NEBRASKA PUBLIC POWER DISTRICT
DOCKET NO. 50-298
COOPER NUCLEAR STATION
AMENDMENT TO FACILITY OPERATING LICENSE

Amendment No. 85
License No. DPR-46

ATTACHMENT TO LICENSE AMENDMENT NO. 85

SAFETY EVALUATION BY THE OFFICE OF NUCLEAR REACTOR REGULATION

Figure 6.1.1
NPPD Nuclear Power Group
Organization Chart

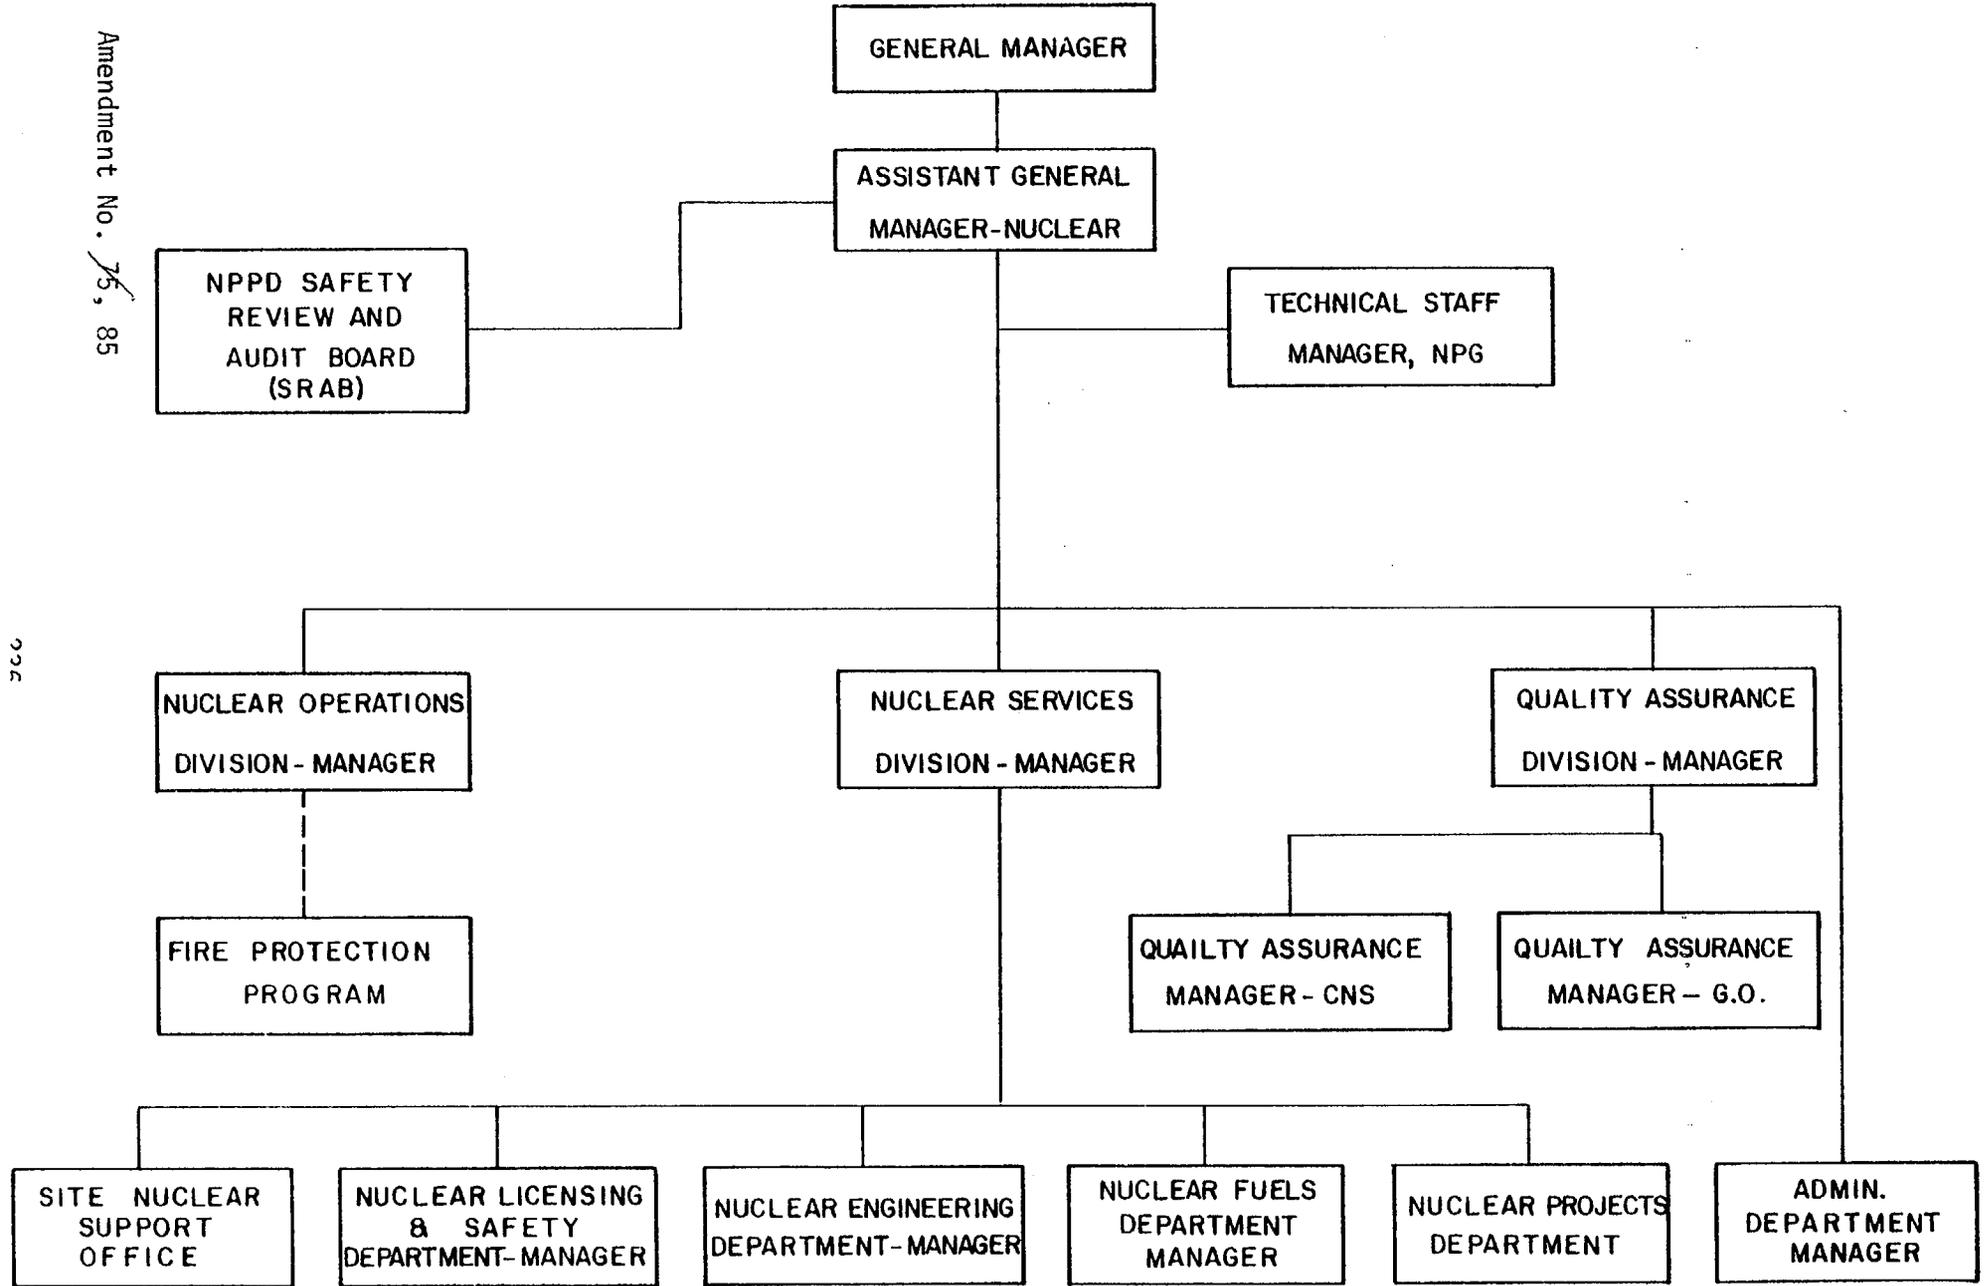
The amendment revises the Technical Specifications to (1) reflect the recent reorganization of the nuclear operations at Nebraska Public Power District and Cooper Nuclear Station, and (2) correct various typographical errors.

We have reviewed the recent management reorganization contained in the licensee's October 26, 1983 submittal. The management reorganization is consistent with the recommendations contained in the management appraisal report prepared by LRS for NPPD. Under this reorganization all nuclear operations and support are consolidated and report to one individual (Assistant General Manager-Nuclear). This should improve the working relationship between the corporate headquarters and the plant and the coordination of the entire nuclear effort within the organization. It is the staffs position that this recent reorganization provides a significant improvement over the old organization and is therefore acceptable.
